HISTORIC AND DESIGN REVIEW COMMISSION

August 18, 2021

HDRC CASE NO: 2021-243
ADDRESS: 207 W MULBERRY AVE
LEGAL DESCRIPTION: NCB 3059 BLK 6 LOT E 33.33 FT OF 20 & W 33.33 FT OF 21
ZONING: R-5, H
CITY COUNCIL DIST.: 1
DISTRICT: Monte Vista Historic District
APPLICANT: Gerald (Jerry) Wilson
OWNER: WATSON ANN KATHRYN & JAMIESON ALEX STEWART
TYPE OF WORK: Front facade and front walkway modifications
APPLICATION RECEIVED: August 03, 2021
60-DAY REVIEW: Not applicable due to City Council Emergency Orders
CASE MANAGER: Rachel Rettaliata

1. Partially demolish and reduce the length of the east wing wall.
2. Modify the existing front walkway.
3. Install a rear patio.

1. **Wing Wall Documentation:** See photo below for requested detail of existing footer mentioned during on-site review

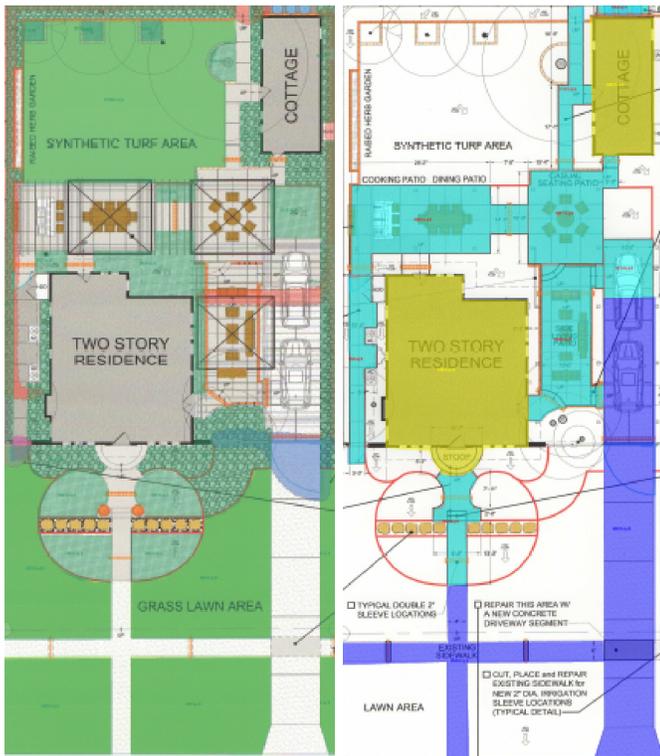
- c. WING WALL MODIFICATION – The applicant has proposed to reduce the length of the east wing wall on the front façade to match the existing west wing wall. The applicant has provided evidence of a wing wall foundation beam extension, showing that the existing west wing wall likely matched the length of the existing east wing wall and was previously shortened. Guideline 7.B.v for Exterior Maintenance and Alterations states that architectural features should be reconstructed based on accurate evidence of the original, such as photographs. If no such evidence exists, the design should be based on the architectural style of the building and

historic patterns. As the length of the existing east wing wall is likely original, staff finds the proposal inconsistent with the Guidelines.

Item 1, staff does not recommend approval of the request to modify the existing east wing wall based on finding c.
